Docket Number:	00-AFC-02C
Project Title:	Mountainview Power Plant - Compliance
TN #:	241555
Document Title:	Mountainview Generating Stations Petition for Staff Approved Addition of Electric Vehicle Charging Stations
Description:	Mountainview Generation Preliminary Submittal - Mountainview EV Charging Petition
Filer:	Jan Whitson
Organization:	Southern California Edison
Submitter Role:	Public Agency
Submission Date:	2/16/2022 12:18:55 PM
Docketed Date:	2/16/2022

SCE MOUNTAINVIEW GENERATING STATION

**PETITION FOR STAFF APPROVED ADDITION
OF ELECTRIC VEHICLE CHARGING STATIONS**

Figure 1
Facility Map

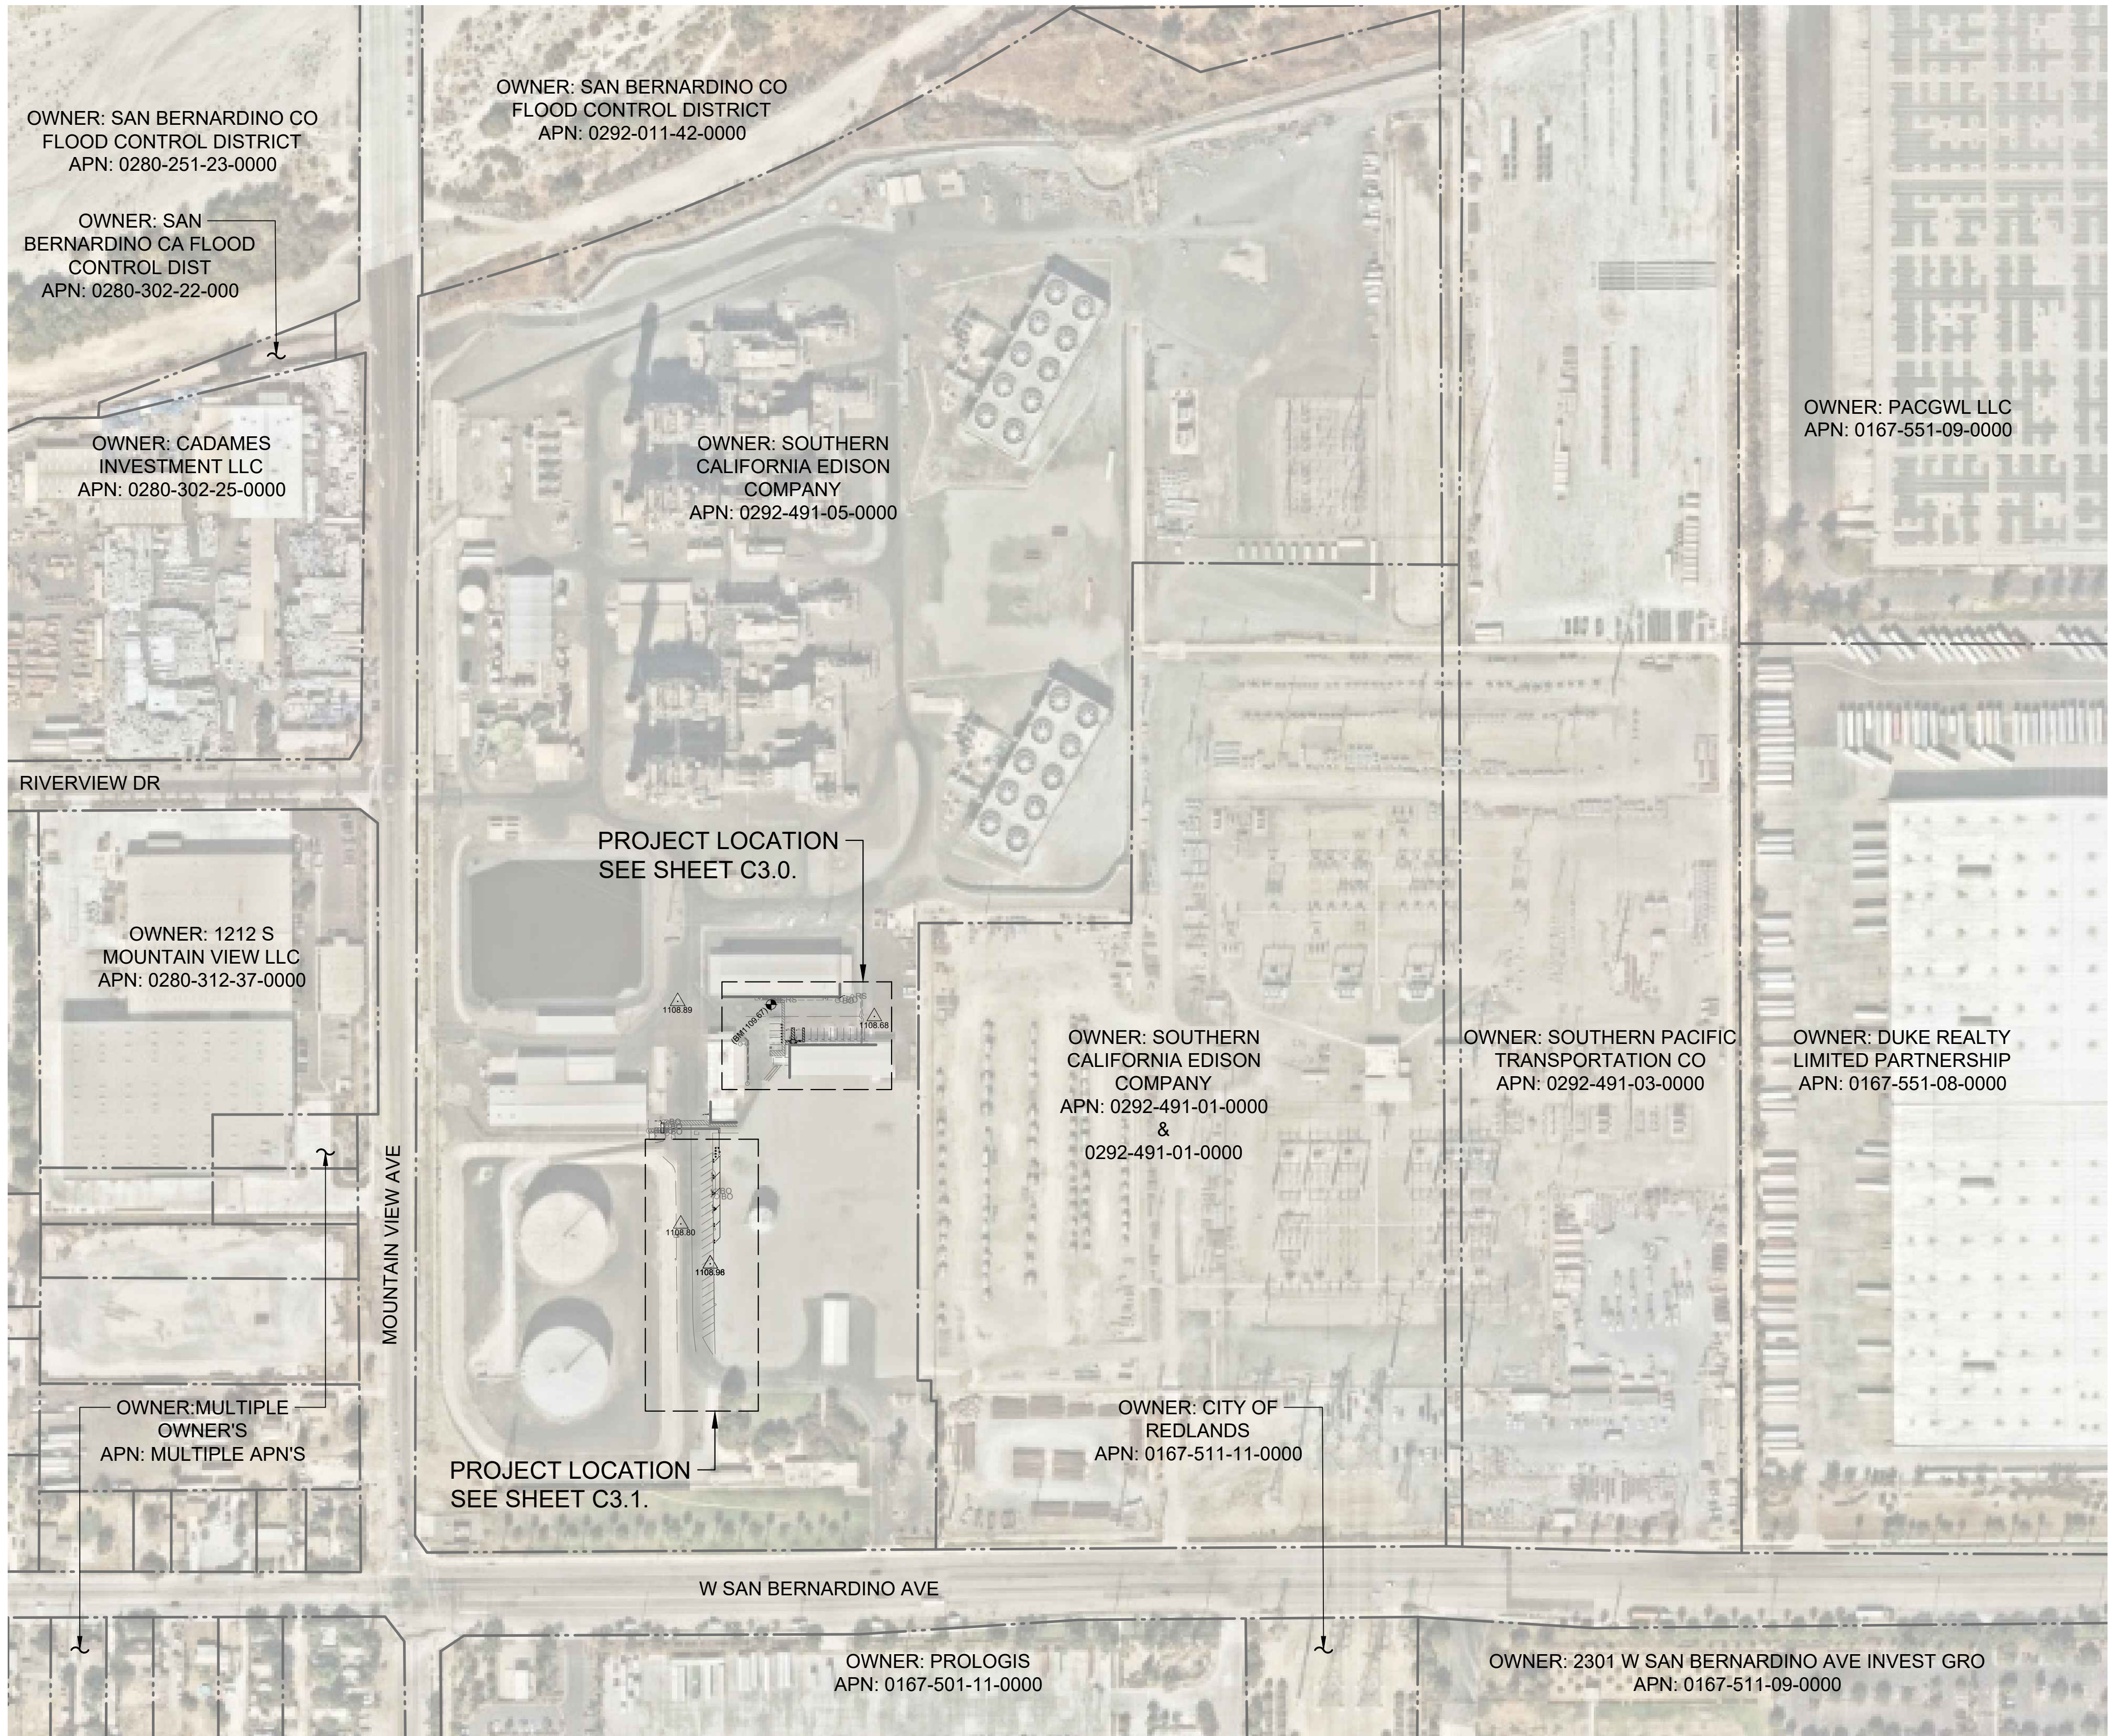
The Mountainview plant is primarily located in a predominantly commercial/industrial area of Redlands, California. The 50+ acre plant site is at the Northeast corner of San Bernardino Ave. and Mountain View Ave. As shown in Figure 1 (below) to the North, the Mountainview plant is bounded by the Santa Ana River/Wash and commercial complexes, including the San Bernardino International airport; to the East, the Mountainview plant is bounded by a SCE transmission substation and commercial complexes; to the South and across San Bernardino Ave., the

Mountainview plant is bounded by commercial complexes; to the East and across Mountain View Ave., the Mountainview plant is bounded by industrial complexes; and diagonally across these streets at the Mountainview plant's southwest corner are residential properties.

A ENLARGED GRADING PLAN
C3.0 1" = 5'-0"

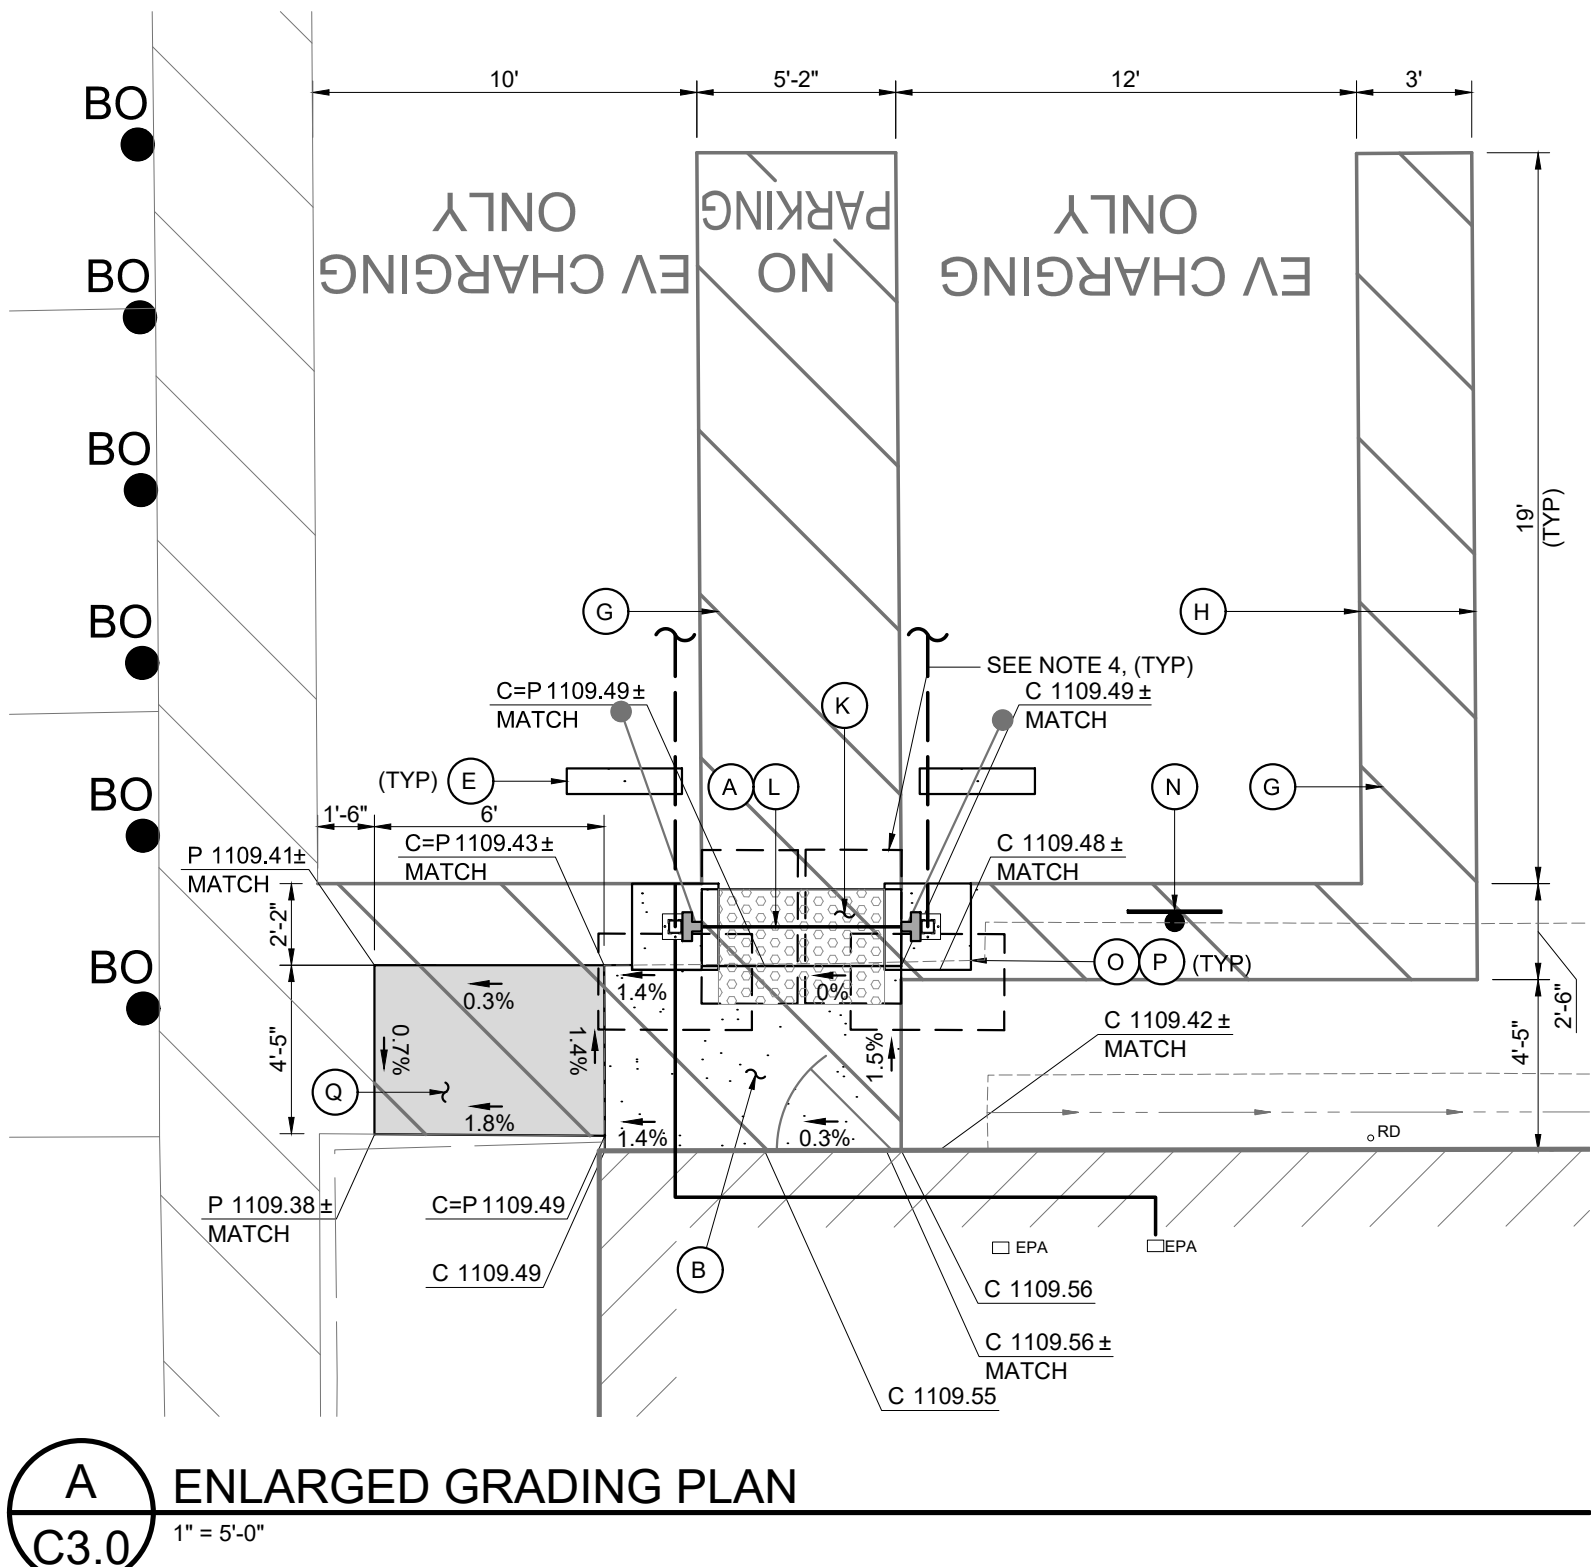
Engineering details regarding placement of EV infrastructure are presented in Attachment A, Sheet C3.0 Detail A and Sheet C3.1. Engineering details regarding depth and connections of EV infrastructure are presented in Attachment A, Sheet C4.0 and Sheet E2.0.
